Notice of Allowability	Application No.	Applicant(s)	
	10/646,706	SUZUKI ET AL.	
	Examiner	Art Unit	
	Donna V. Lui	2675

DETAILED ACTION

EXAMINER'S AMENDMENT

FIG. 2

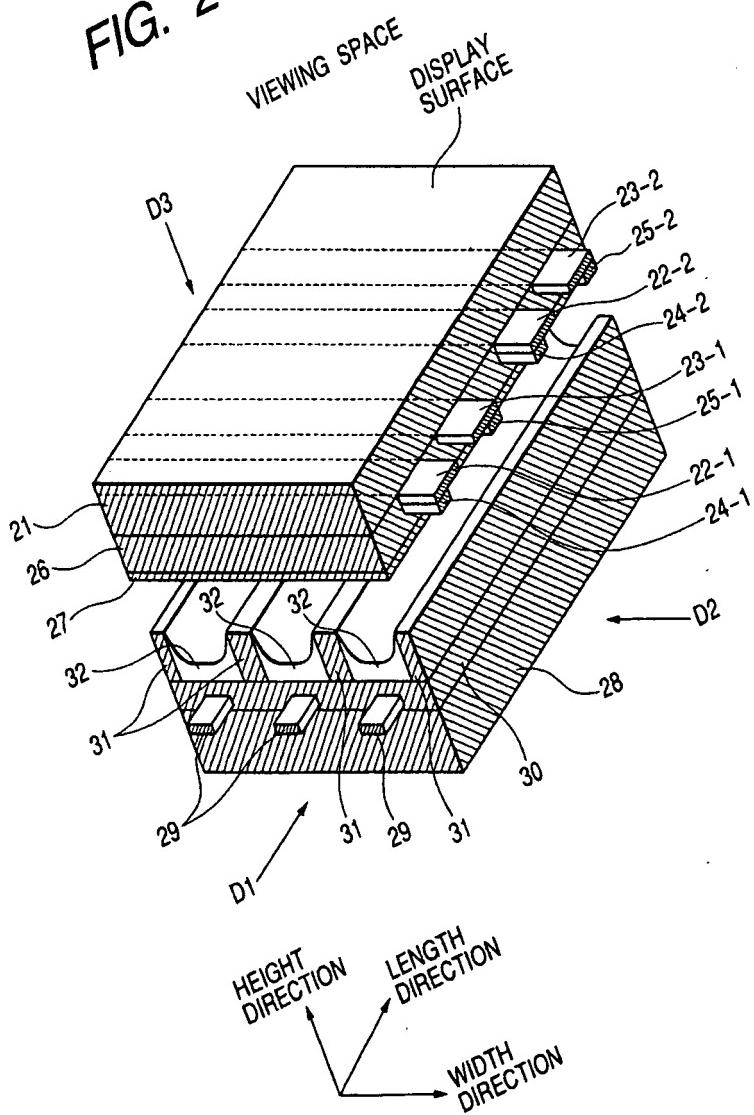
Figures 2-7 labeled as – “**Prior Art**”.

PRIOR ART
